Beenup power supply

State Energy Commission of Western Australia

**Report and recommendations
of the Environmental Protection Authority**

Figure 2:

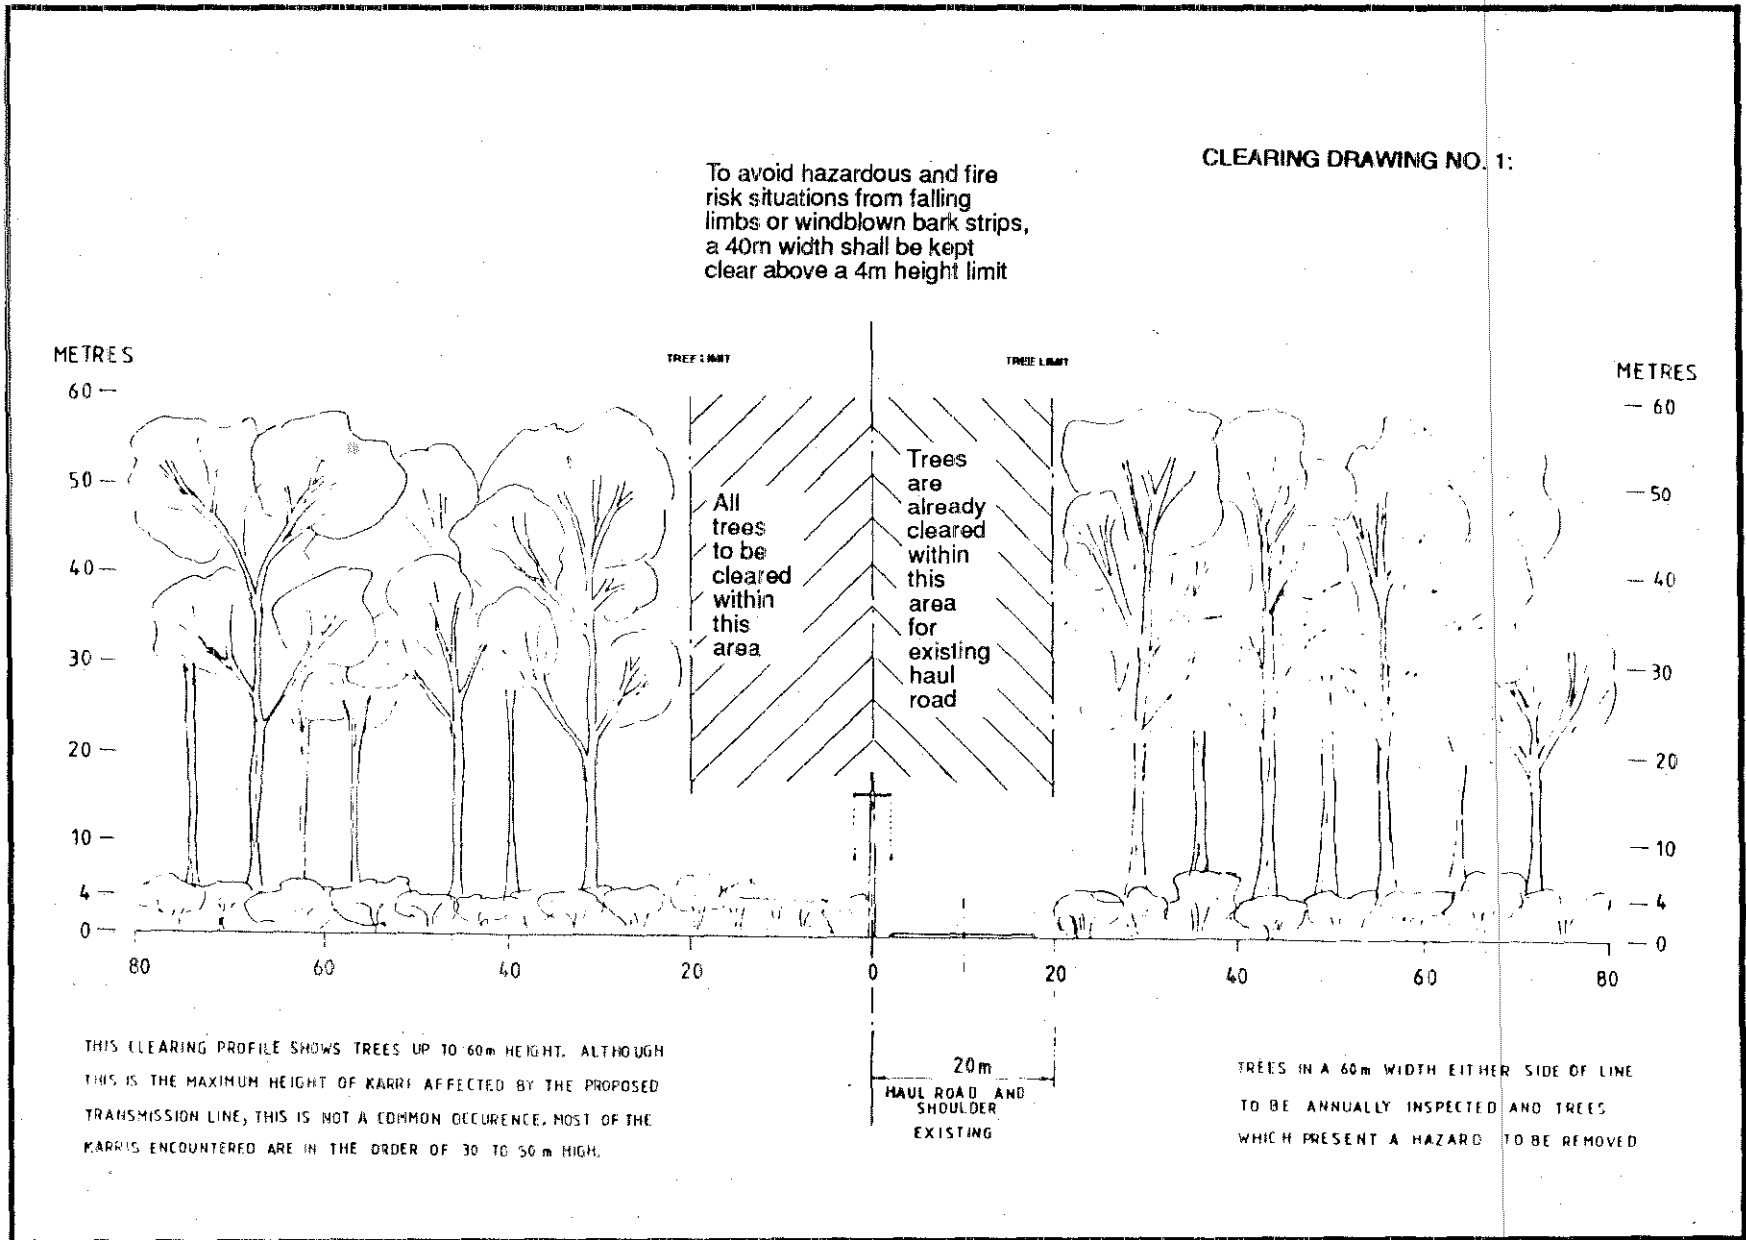
Clearing profile - use of logging haul roads and foregoing tall tree clearing practice in existing, and proposed conservation areas and all other forest areas will minimise clearing. The use of logging haul roads will reduce clearing to 20m. (See Figure 2.)

Poles - use of wooden or concrete poles (approximately 20m in height) with a pole top configuration. (See Figure 2). The Authority has recommended use of poles for the whole corridor. This will minimise visual impact and result in less ground disturbance.

The Environmental Protection Authority recommends that the reduced clearing profile and pole configuration proposed by SECWA and illustrated in Figure 2 apply to the entire length of the proposed corridors.

The pole configuration proposed for the Karri area is in the Authority's belief, a significant improvement on the use of steel towers. The poles by virtue of their reduced height should have significantly less impact in terms of visual intrusion than that of the steel towers originally proposed. It is noted in SECWA's response to issues raised (for example response to Issue 3, Submission 3) that it is expected that poles could show a cost advantage over steel towers. For this reason, the Authority considers that the pole configuration as shown in Figure 3 should be used for the entire route from Manjimup to Beenup. In addition, the clearing profile shown in Figure 3 (maximising the use of existing haul roads or forest tracks and not clearing outside of the easement), should also apply to the entire route so as to reduce the amount of vegetation which would have to be cleared. (See **EPA Recommendations 3 and 4.**)

The Environmental Protection Authority recommends that the reduced clearing profile and pole configuration proposed by SECWA and illustrated in Figure 2 apply to forest areas along the entire length of the proposed corridors.

Figure 3: Areas recommended for line to be undergrounded

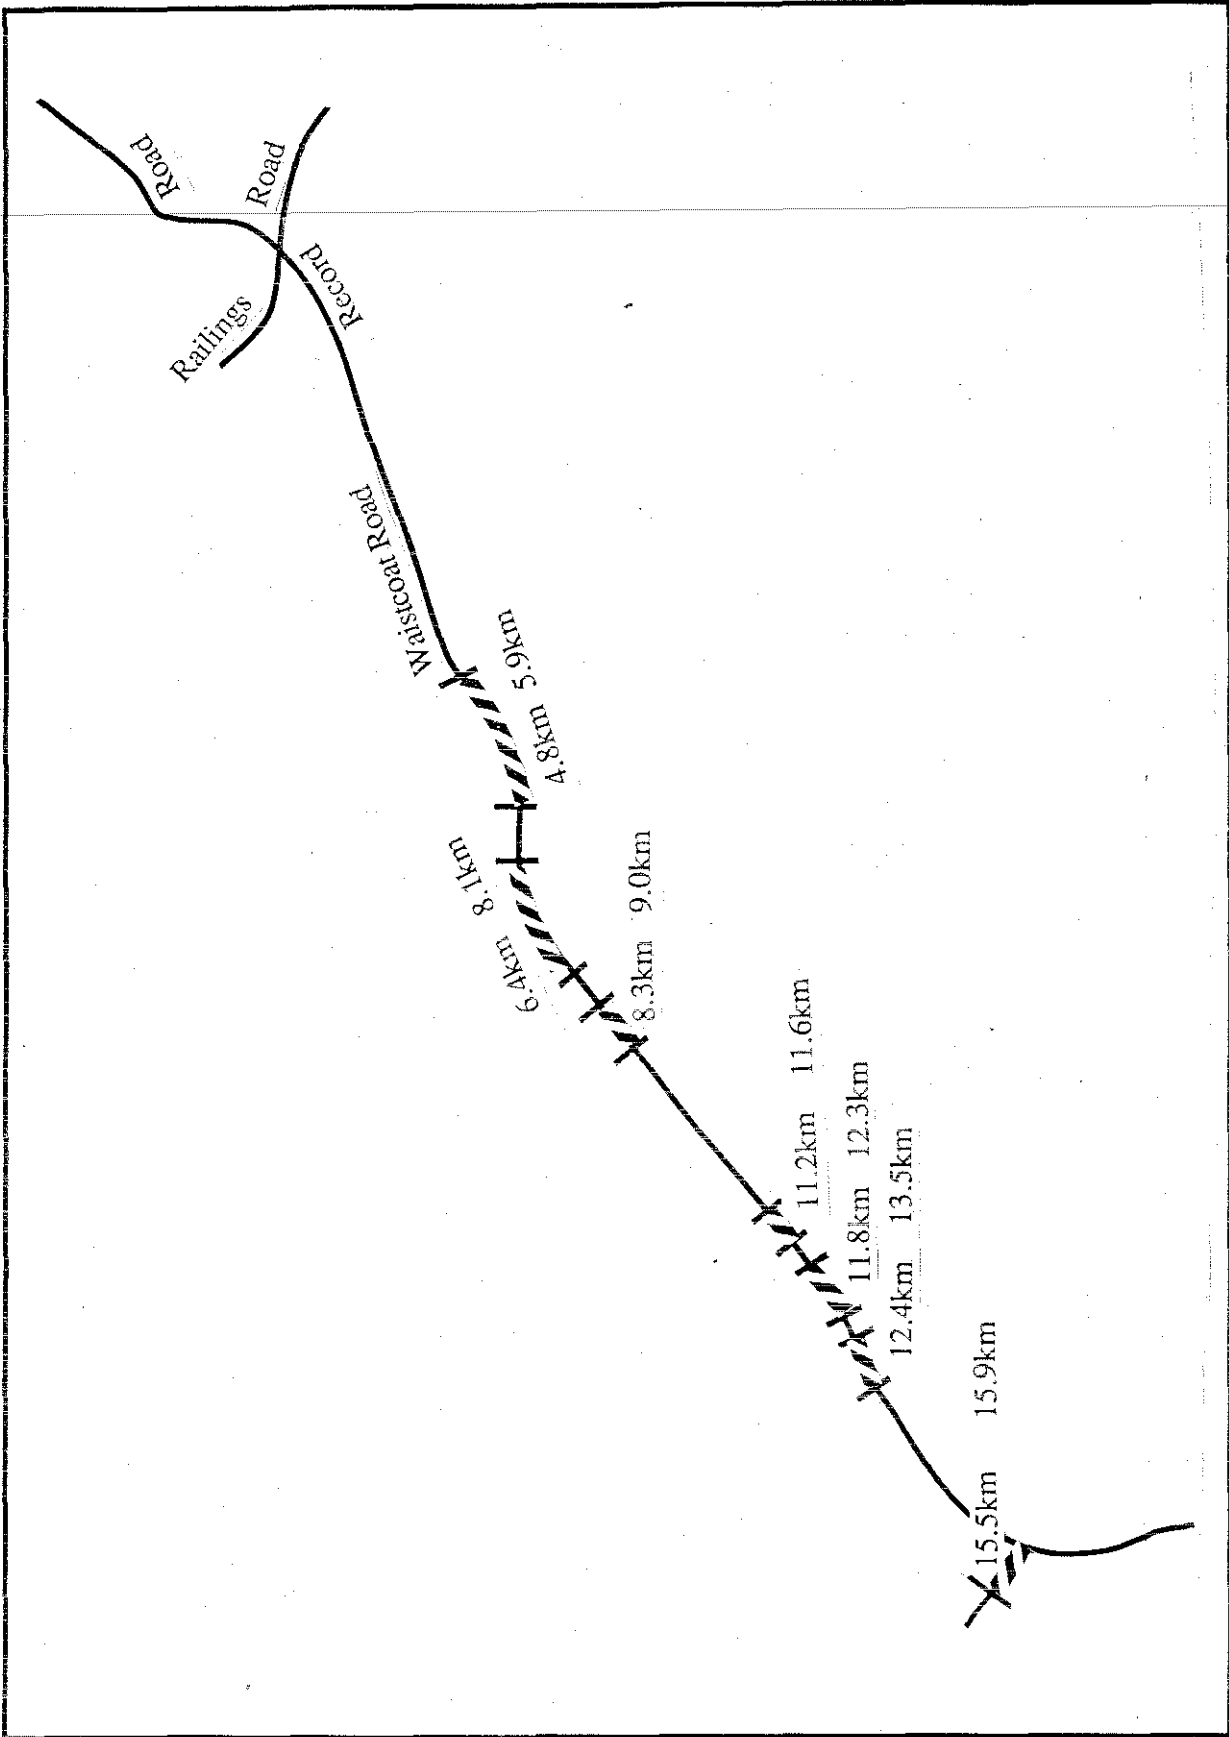
Conservation value - the Authority has recommended that no clearing of certain areas of forest of a high conservation value occur. In certain areas shown in Figure 3, it will be necessary for the transmission line to go underground.

The Environmental Protection Authority recommends that the Manjimup option is acceptable only if the proponent does not clear forest of a high conservation value. In these areas, as indicated in Figure 3, the power line should be placed underground. Minor modifications to the areas indicated in Figure 3 should only be made to the satisfaction of the Environmental Protection Authority on advice of the Department of Conservation and Land Management.

In order to make the Manjimup option acceptable areas of quality forest should be avoided by undergrounding the power line in the areas indicated in Figure 3. (See **EPA Recommendation 5.**)

The Environmental Protection Authority recommends that the Manjimup option is acceptable only if the proponent does not clear forest of a high conservation value. In these areas, as indicated in Figure 3, the power line should be placed underground. Minor modifications to the areas indicated in Figure 3 should only be made to the satisfaction of the Environmental Protection Authority on advice of the Department of Conservation and Land Management.
